CAPISTRANO BEACH

WETLANDS DELINEATION

DEPARTMENT OF THE ARMY
LOS ANGELES DISTRICT, CORPS OF ENGINEERS
PO BOX 532711
LOS ANGELES, CALIFORNIA 90053-2325

The purpose of this letter is to respond to your request for information concerning our determination of geographical extent of waters of the United States, located at the 2-acre site known as the Castillo del Mar development, along Camino Capistrano in the community of Capistrano Beach, in the city of Dana Point, Orange County, California.

EXHIBIT 7

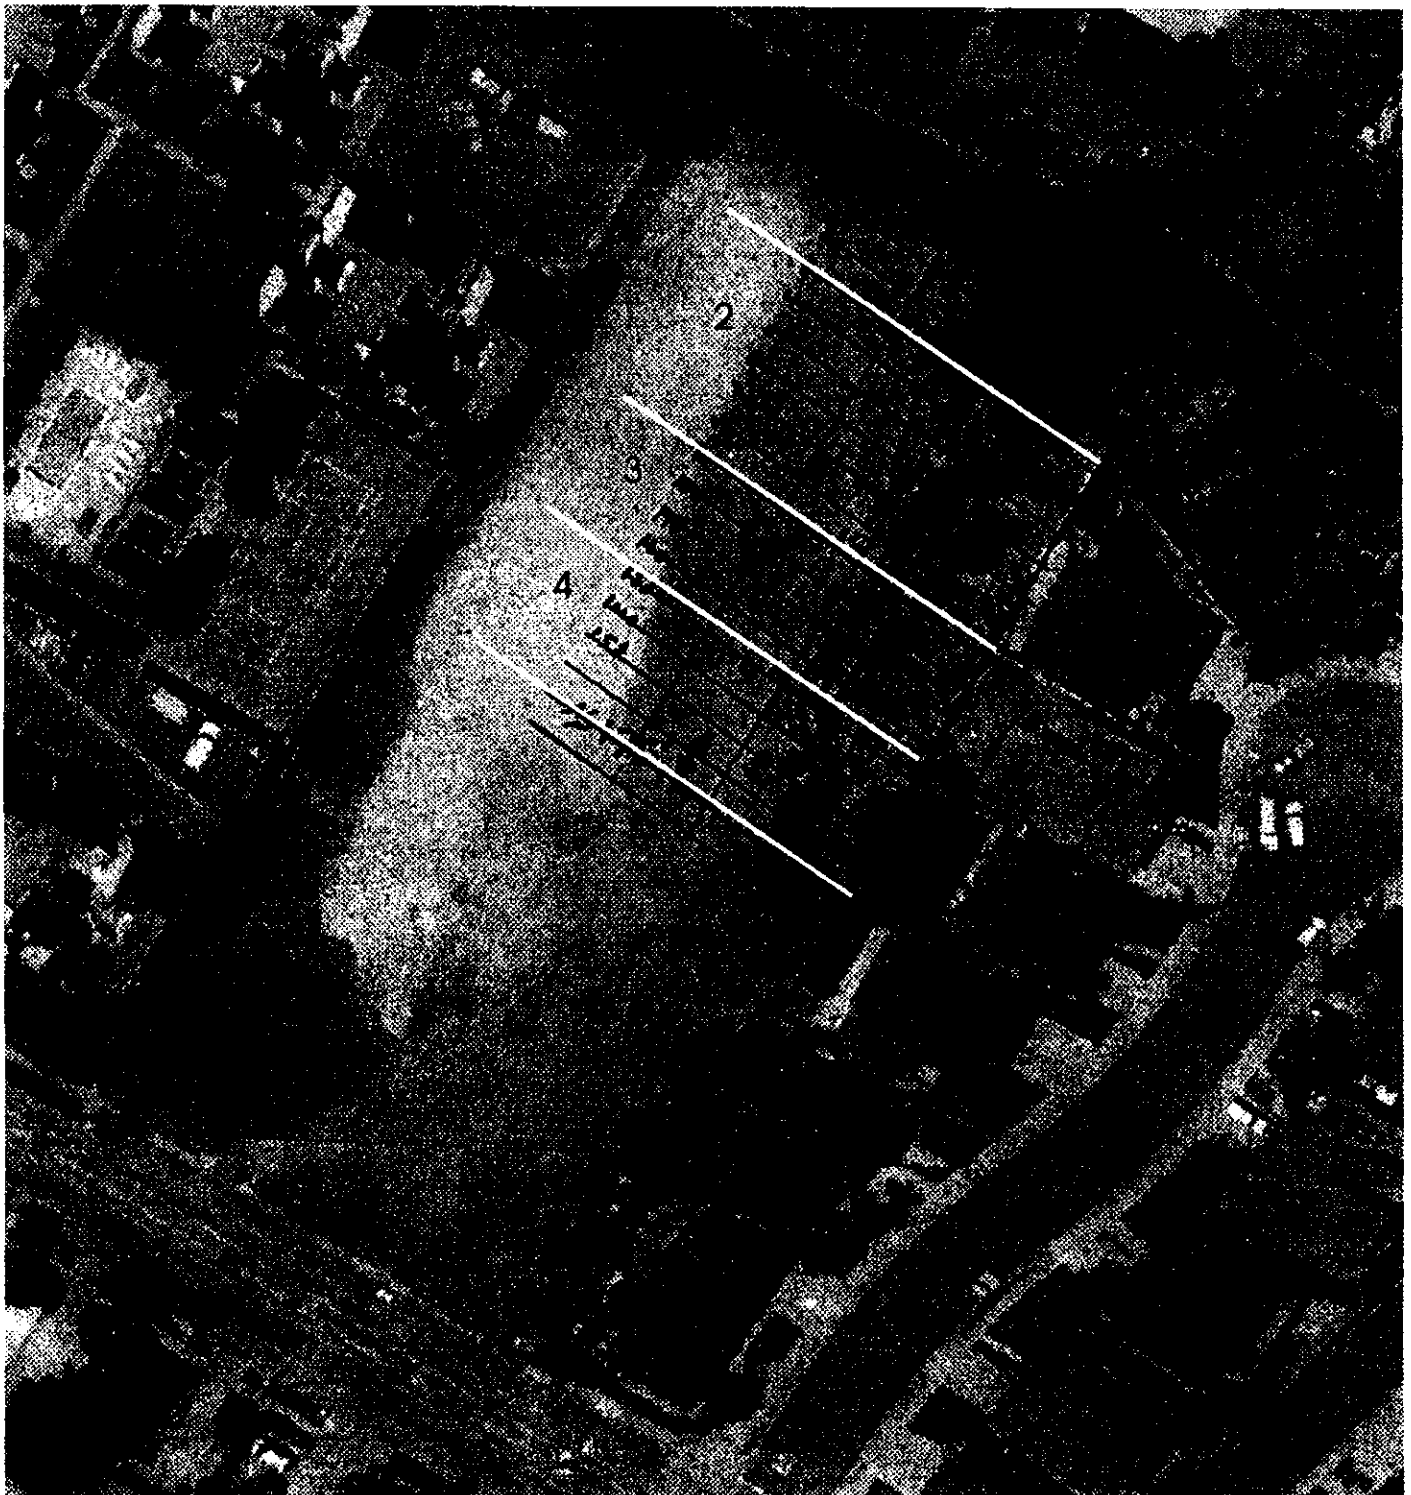
We took Tony Bomkamp's field drawings and overlaid them on the original wetlands aerial photo to disprove his length and various widths.

On the overlay, we divided up the wetlands into four (4) locations. The enclosed photos show that Tony Bomkamp's field drawings do not show the actual water line of our wetlands.

Location 1 - Exhibits 8, 9, 10 & 11 show the vegetation of approximately 55' in width. The water line is approximately 30' wide as denoted by Exhibits 17, 18, 19 & 20.

Location 2 - Exhibits 8, 9 & 11 shows the vegetation to be approximately 45' in width. The water line is approximately 25' as denoted by Exhibits 17, 18 & 22.

Location 3 - Exhibits 11 shows the vegetation to be approximately 40' in width. The waterline is approximately 25' as denoted by Exhibits 16, 17 & 18.

Location 4 - Exhibits 11 & 12 shows the vegetation to be approximately 30' in width. The waterline is approximately 20' as denoted by Exhibits 17 & 21.

EXHIBIT 20

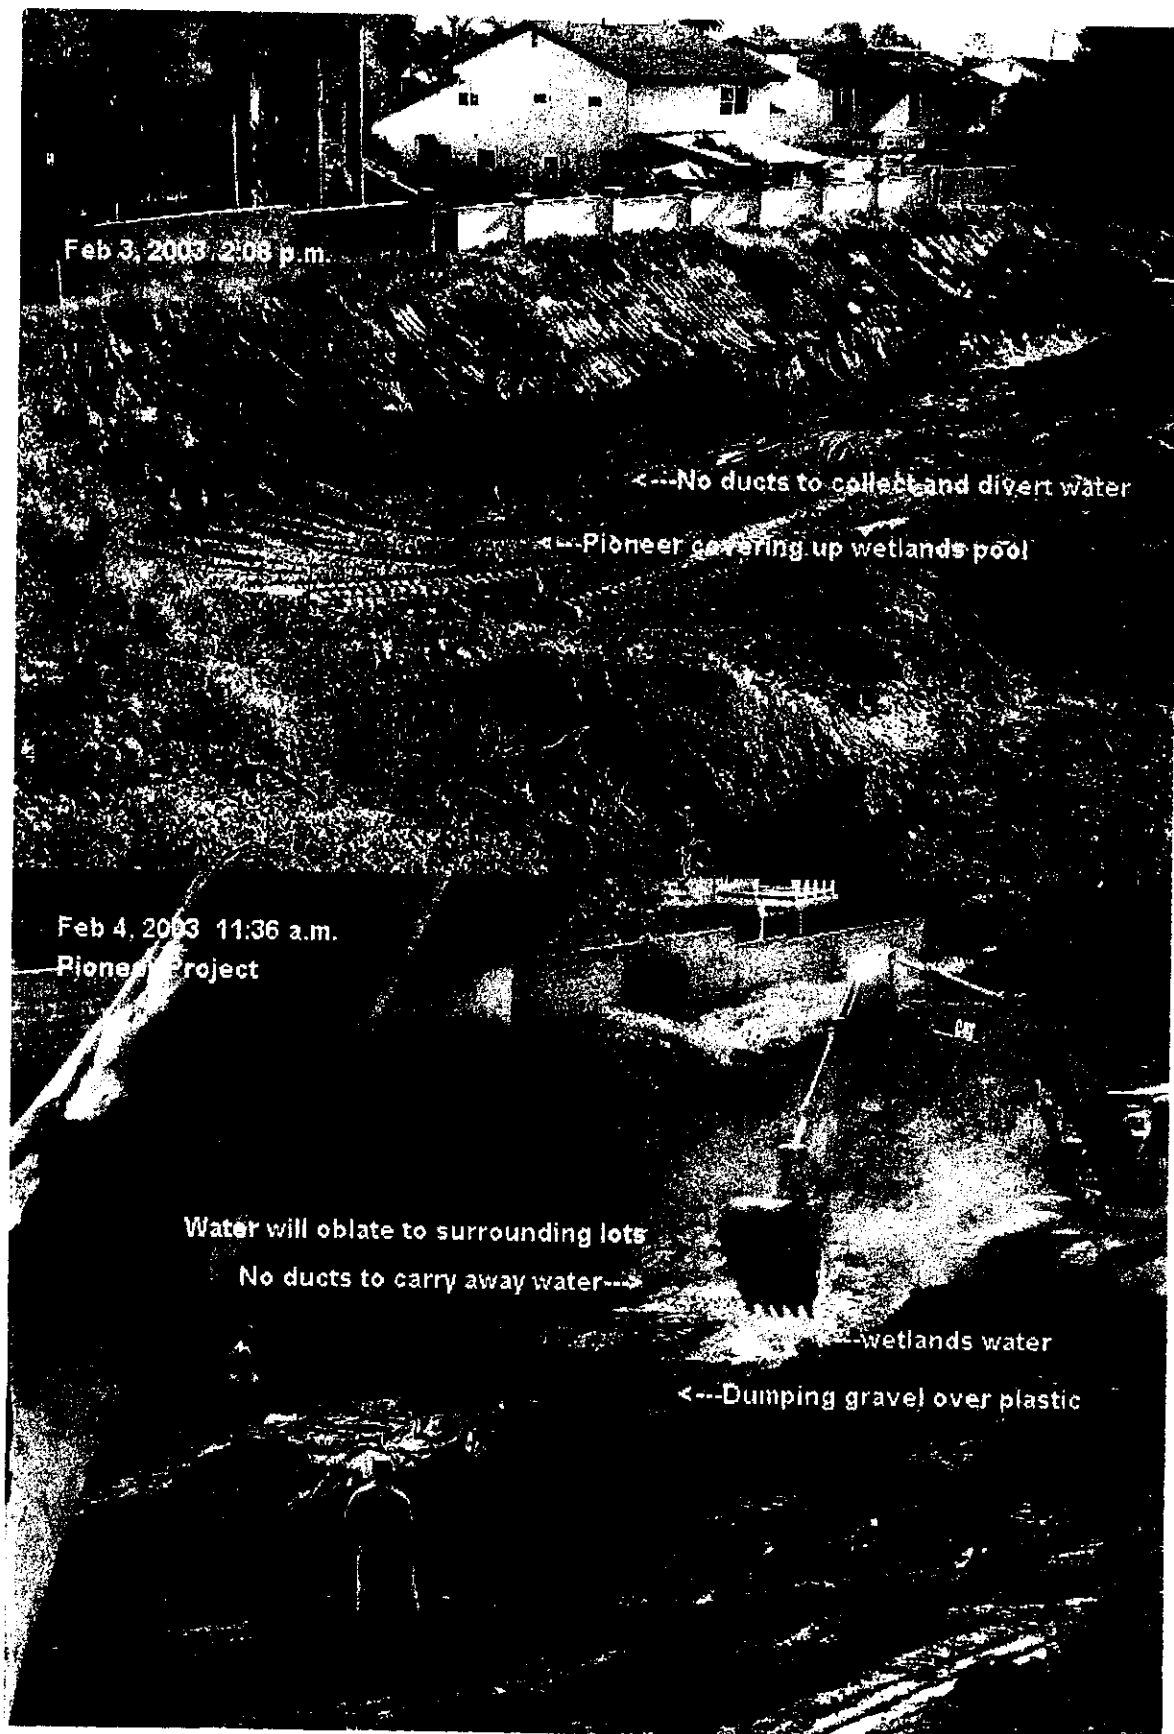
Exhibit 20 - More excavating and wider.
